**Amendments to the Drawings**

# Appendix A

FIG. 1

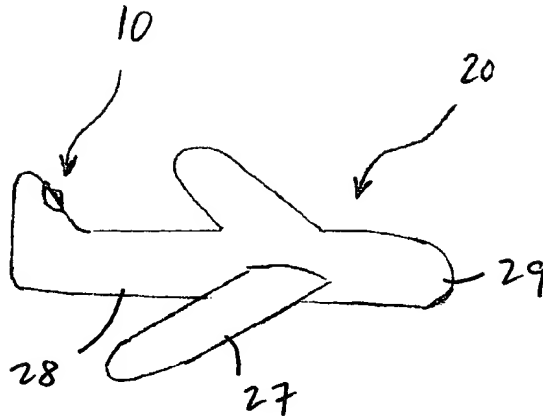
Please amend FIG. 1 of the drawings by adding reference numerals 27, 28, and 29 as clearly shown on the first replacement sheet of Appendix A. The additions of these three reference numerals accords the specification at page 3, lines 23 and 24.

FIG. 4b

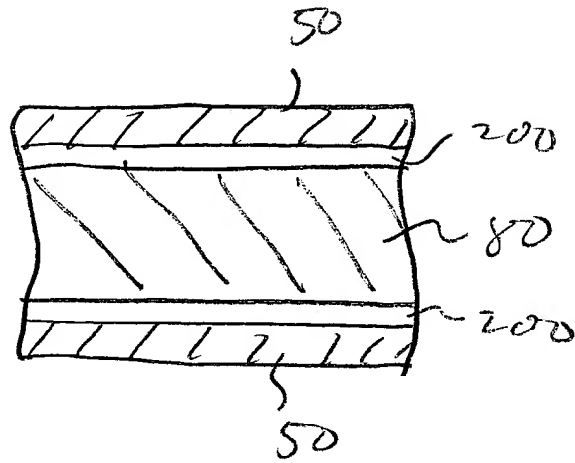
Please add new FIG. 4b to the drawings as shown on the second replacement sheet of Appendix A. New FIG. 4b has been added because it would have been difficult to indicate space 200 by adding a reference number to FIG. 4 as filed, because in FIG. 4 as filed, the space is filled with filler 210; therefore, a new reference numeral in FIG. 4 would have indicated essentially the same element as filler 210. Therefore, the addition of new FIG. 4b was deemed necessary to clearly illustrate the space between the camera and the receptacle. It is respectfully submitted that no new matter has been added to the application by the addition of FIG. 4b.
